SERVICE BULLETIN NO. 97

SEC. VIII, DIV. A
SERVICE BULLETIN
ISSUED, FEB., 1963
Revised April, 1965

INSTALLATION OF RE-DESIGNED OIL DISTRIBUTOR 220-37 AND ROD LOCK 148-42

220-37
New Style

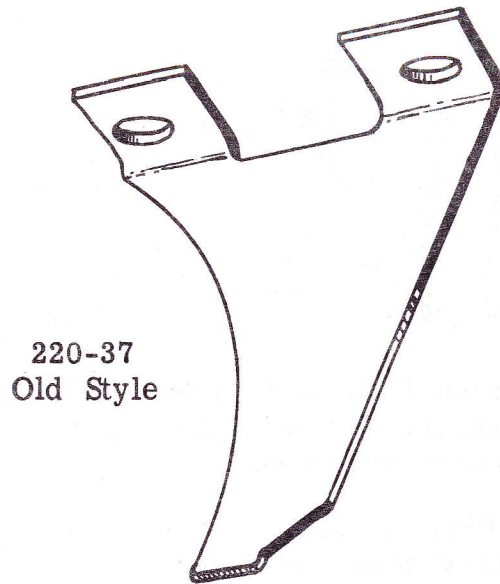
The 4007 (220-37) Oil Distributor has been re-designed. The new Oil Distributor will carry the same part number, however, it will have a $3/16$ hole drilled in the lower part for identification, and is manufactured from $5/64$ metal. The older 220-37 Oil Distributor was made of $3/64$ metal.

When installing the new style Distributor the 148-42 Rod Lock must be used in place of the 304-114 Rod Lock as called for in the past. Care should be taken when installing new Rod Lock 148-42. Crimp ends so sufficient clearance between Rod and Block and Camshaft is maintained.

CAUTION: If no Oil Distributor is required or the old style Oil Distributor is reused, the old style Rod Lock, Part No. 304-114 must be used.
